RECALL: "TANGO" connector incorrect marking

mod. KONG TANGO # 715.000

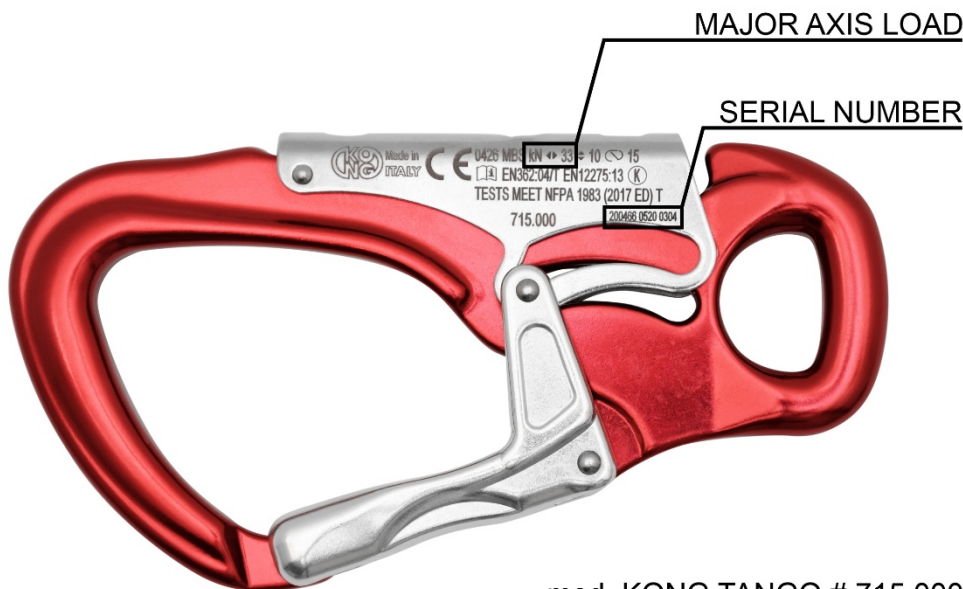
During our quality control procedures, we identified incorrect markings of the strength rating along the major axis with the gate closed on two batches of the connector model "TANGO".

The connector shows an incorrect value of 50kN instead of the correct strength rating of 33kN.

Improper marking may lead users to apply a load up to 50kN causing possible breakage of the connector, that is tested to a maximum load of 33kN.

Verify that the strength marking along the major axis with the gate closed is 33kN.

Below the examples of correct marking, and wrong marking.

In order to avoid any possible misuse (i.e. overloads), the connectors with the wrong marking (50kN) shall be taken out of service, and replaced.

KONG will collect and replace the connectors with others of the same model, but correctly marked (33 kN).
